January 20, 2016
Project No. 9101110001

Subject: Response to WAFB – ADEQ Comments
ST012 SEE Weekly Progress Reports
Oct. through week ending November 9, 2015
Former Fuel Storage Area (ST012)
Former Williams Air Force Base
Mesa, Arizona

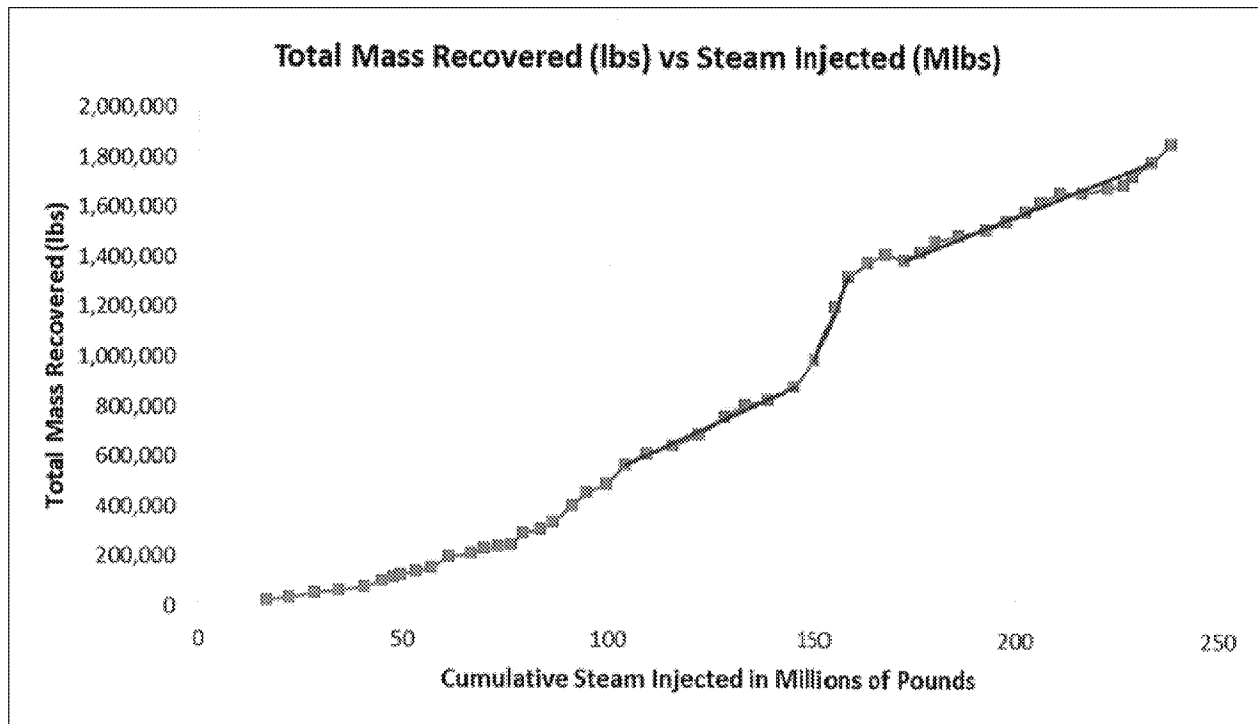
1. The inability to assess mass removal from individual treatment intervals (CZ, UWBZ, LSZ) hampers performance evaluation. (Oct. 2015).
2. The data do not indicate a significant decay in recovery rate after breakthrough. (Oct. 2015)
3. Clarify mass removal rate (Nov. 2015).
4. Verify benzene feedwater concentration (Nov. 2015).

The cumulative mass removal plotted in Figure 3 shows an inflection point for a decrease in the rate of mass recovery around June 20 coinciding with the initiation of de-pressurization in the LSZ. The inability to assess mass removal from individual treatment intervals (CZ, UWBZ, LSZ) hampers the evaluation of performance.

The total mass recovery is plotted below as a function of cumulative steam injected instead of date. Steam breakthrough in a number of wells may coincide with the jump in mass recovered between the cumulative steam injection of 150 to 160 Mlbs. However, the rate of mass recovery, illustrated by the slope of the red line, is similar in value before and after the jump in mass recovery. The data do not indicate a significant decay in recovery rate after breakthrough. Similarly, the NAPL recovery alone is also plotted as a function of cumulative steam injected instead of date. The NAPL recovery rate remains relatively steady from 160 million pounds of steam and beyond.

Response: *As presented in the RAWP, the basis of design for the SEE system did not include the capability to assess mass removal from individual treatment intervals (CZ, UWBZ, LSZ). The system performance is measured by data collected through the process based on a combined process stream from all three treatment intervals. TerraTherm and Amec Foster Wheeler have been collecting jar samples from each of the MPE wells since 23 October 2015 to provide an indirect indicator of the locations and zones where NAPL is produced. The collected data are presented in the weekly operational progress reports.*

Response: The total mass recovery rate has decreased over time since peaking in mid-May 2015 at a rate above 22,000 lbs/day. Mass removal rates have since decreased, but have remained relatively constant the past several months, albeit at varying recovery rates, influenced by the pressure cycling events. The total mass recovery rate has shifted from primarily being comprised of NAPL recovery prior to the peak, to primarily being comprised of mass removed as vapor (vapor and dissolved phase concentrations processed through the air strippers) post mass removal peak. As indicated in Table 4-2 of the RDRA WP, mass contribution from outside the TTZ may mask the progress of mass removal within the TTZs, so the contribution of perimeter/interior extraction wells is being evaluated to identify the extent to which perimeter influx is contributing to the mass removal rate. Based on information presented in the December BCT teleconference, total mass removal is less than 20% of the peak and is approaching the 10% target. A recent coordinated depressurization event in all three zones beginning 28 December 2015 resulted in an increase in LNAPL recovery and pushed overall mass removal rates up to 40% of the peak..

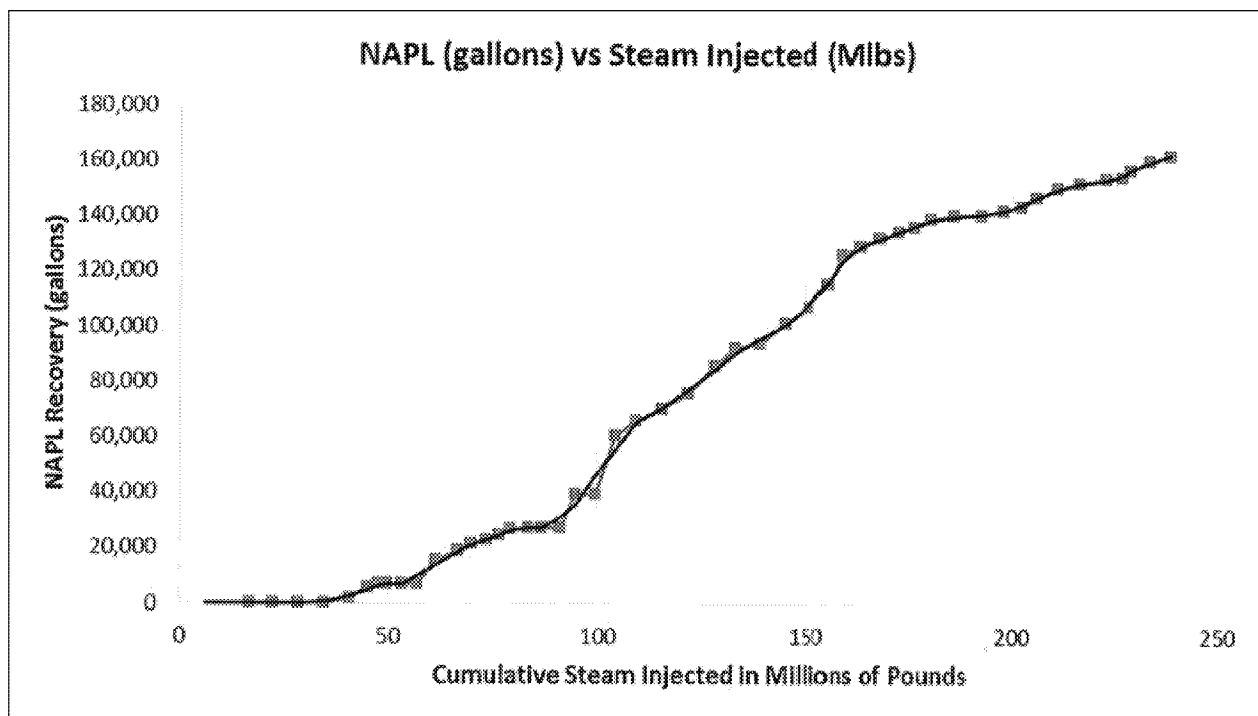
The reported mass removal rate 3,800 gallons for the week does not appear to have significantly decreased. Consider the reported 0 gallons of NAPL recovery, but the equivalent vapor treatment recovery.

Response: Overall mass removal is calculated as the sum of mass removed as NAPL and mass removed in the vapor phase. The NAPL extracted with the water from the wellfield is separated from the liquid stream in the front end of the liquid treatment system, conditioned and then sent to the NAPL storage tanks. The NAPL volume (gallons) is recorded by a NAPL flow meter and

the mass is then calculated using a NAPL density of 6.57 lbs/gallon. The vapor mass removal is quantified by measuring the concentrations at the influent to the thermal accelerators (both based on PID and laboratory samples) and multiplying the concentration by the flow of vapor treated. The vapor contribution is coming from the vapors extracted from the wellfield combined with the effluents from the air strippers. The air stripper vapors are providing the majority of the total mass removed in the vapor phase.

We agree that the overall mass removal rate has been relatively consistent but that the source of the mass has been shifting until the recent coordinated depressurization from NAPL to vapor. During the recent coordinated depressurization event NAPL recovery has increased, likely due to the larger inward gradients established than during previous operations. These larger gradients may be pulling NAPL into the TTZs. Vapor mass recovery has also decreased during the coordinated depressurization likely due to at least partial collapse of the steam bubble. These conditions are expected to reverse once the site is re-pressurized.

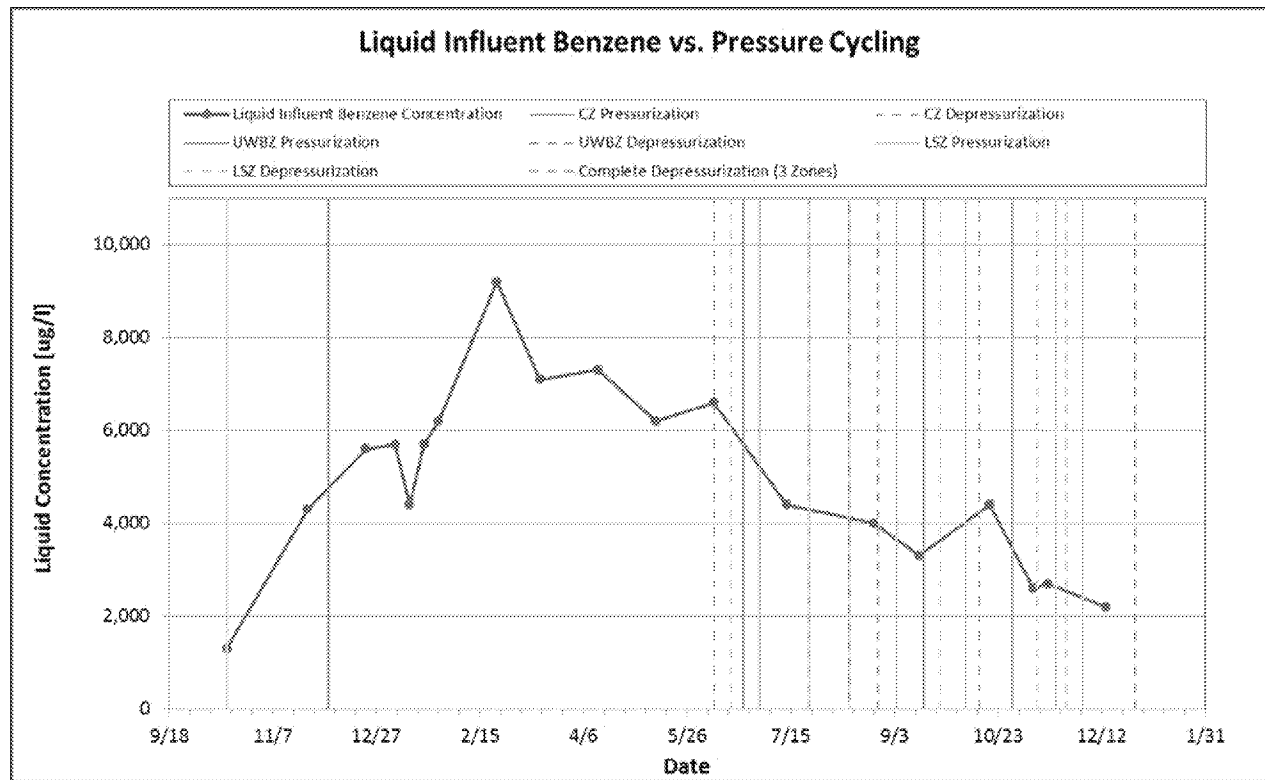
The data do not show a benzene decrease in the extracted groundwater. Consider the benzene in the feedwater to the eductor pumps should be going down since the water is continually recirculated.

Response: *The dissolved phase benzene feedwater concentrations detected over time are shown in the figure below, represented by the air stripper influent benzene concentrations. As seen in the figure below, the dissolved phase benzene concentrations have declined from the peak benzene concentration observed in late February 2015.*
